Product Change Notification

PCN No: 2024-12-02-01
Report Date: December 2, 2024
Subject: MOS-AL162F Header Population Changes

Product Change:

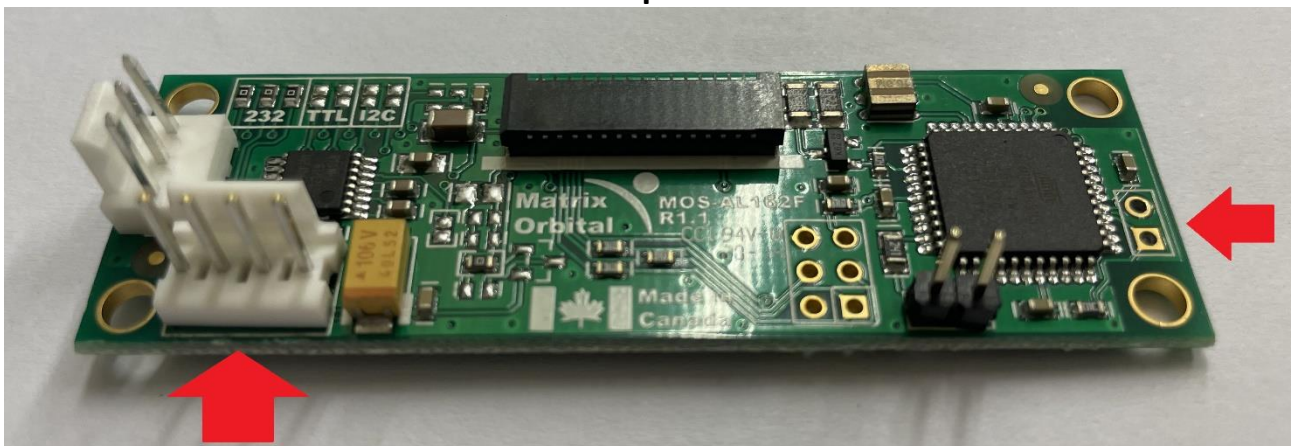
For consistency with other Matrix Orbital's alphanumeric displays, power and communication header on the MOS-AL162F is changed to a polarized locking header similar to Tyco 640456-4.

The 2-pin header populated on MOS-AL162F (found on the right side) does not add functionality and is therefore being removed.
